Memorandum

To: John Uphoff, Tenaska

Re: Response to NPS Inquiry regarding Noise

Below is a response to the NPS inquiry regarding noise impacts of the proposed Brownsville Generating Station. Each NPS comment regarding noise is restated and then a response is presented.

Figure 6-7a
Sound Contours at
Palo Alto Battlefield
National Park

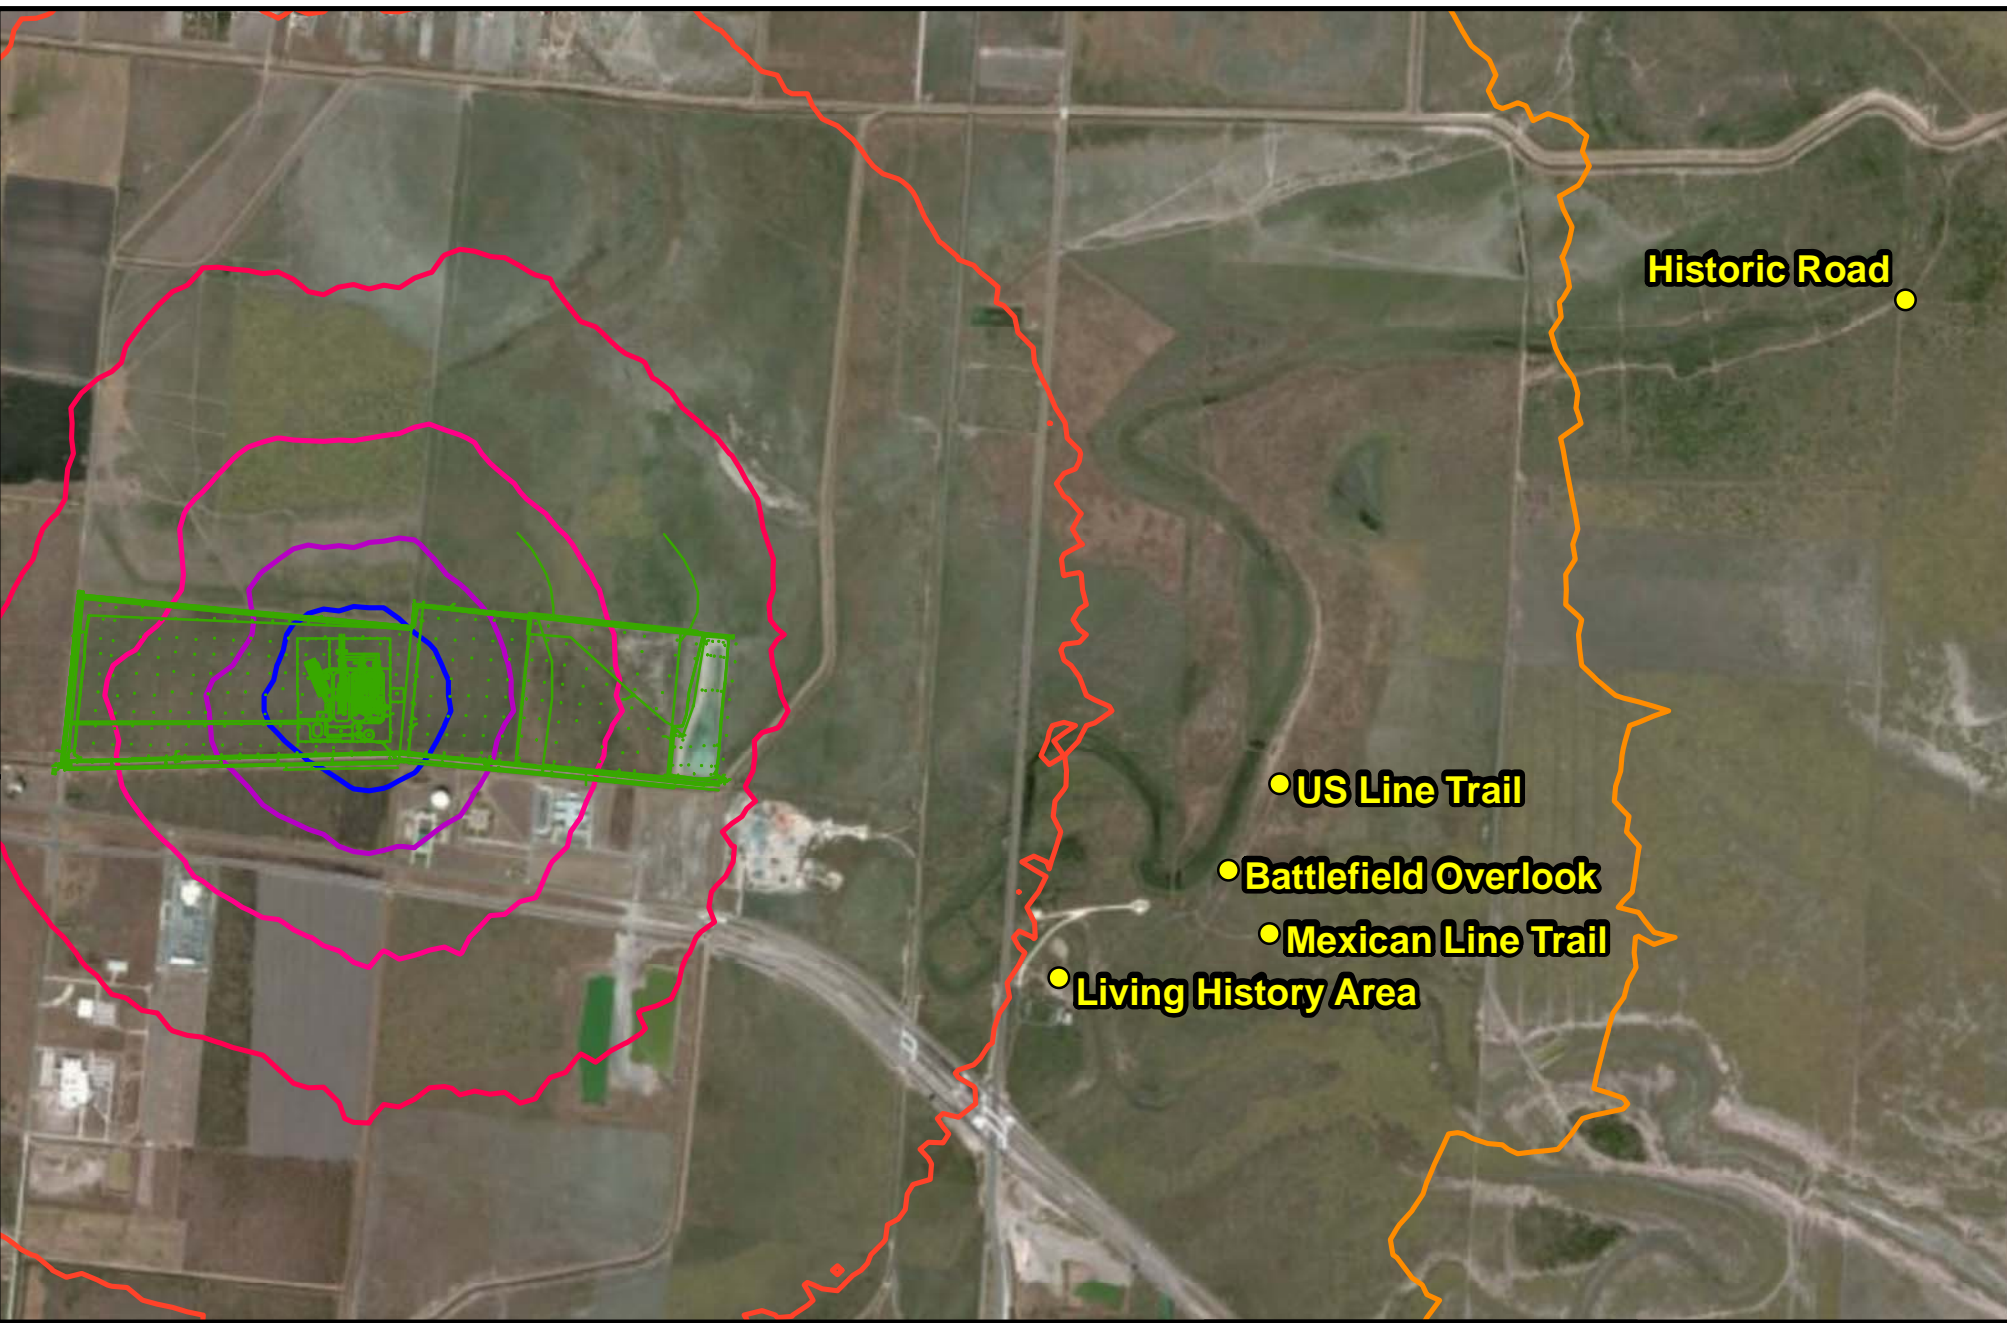
The NPS suggests that the receiver locations in Table 6-5 and Figures 6-6 and 6-7 (pp. 73 and 74) be updated to better represent sensitive cultural soundscape locations (for the historic property).

The predicted noise level increases in Table 6-5 are anticipated to increase further with the lower ambient sound levels expected in the NHP and NHL. In addition, the NPS anticipates that audibility and noticeability of the generating station will be greater than predicted using the "just

noticeable” and “clearly noticeable” criteria for Table 6-5 noise level increases. Given that audible effects to the historic property would very likely be greater than predicted, the NPS urges Tenaska to consider all reasonable techniques for mitigation of noise to the NHP and NHL. The NPS gathered from our 3/12/14 face-to-face meeting with Tenaska that the noise specifications of generating station equipment have already been established and the creation earth berms is one of the only practical options for noise mitigation. The NPS requests that Tenaska create a new figure in addition to Figure 6-7 that shows predicted generating station noise contours with the addition of an earth berm on the east side of the generating station. We also request that Tenaska and its noise consultant carefully consider minimum earth berm height and the height of high sound pressure level (SPL) noise sources such as blowers, turbine inlets/exhausts, compressors, and steam blows from pressure release valves. Wherever possible, the height of high SPL noise sources should be kept or moved below the height of the earth berm. The earth berm may also be used to minimize the visual effects of light and moving steam on the landscape.

Response: The locations of these receivers have been incorporated into the revised and attached Figure 6-6 and Figure 6-7. Additionally, the attached Table 6-5a incorporates MP4. The ambient sound levels presented for MP4, where appropriate, have been adjusted per the face-to-face discussions on 3/12/14. Those adjustments involved generally reducing sound by 3 decibels per doubling of distance. This was accomplished using the equation $L_{p2} = L_{p1} - 10 \log (D_2/D_1)$; where L_{p1} is a known sound level at distance 1 (D_1) from a listener, and L_{p2} is an unknown sound level at known distance 2 (D_2) from a listener.

Response: Presented in the revised Table 6-5a are the surrogate L_{50} data, modeling results, cumulative sound levels (i.e., logarithmic addition of surrogate L_{50} and modeling results), and the expected increases over the surrogate L_{50} sound levels. Results are presented for the base facility operation and then an alternate scenario where a 15-foot tall berm is constructed.

To graphically demonstrate the effect the berm would have towards reducing sound levels in the NHP and NHL, Figures 6-7a and Figure 6-7b have been created and are attached. Figure 6-7a represents the base, no-berm scenario while Figure 6-7b represents the 15 foot berm scenario. As can be seen in the attached table and figures, a 15-foot tall berm has a minimal effect on reducing sound level impacts in the NHP and NHL (i.e., there is predicted to be less than a 3-dB decrease due to the berm).
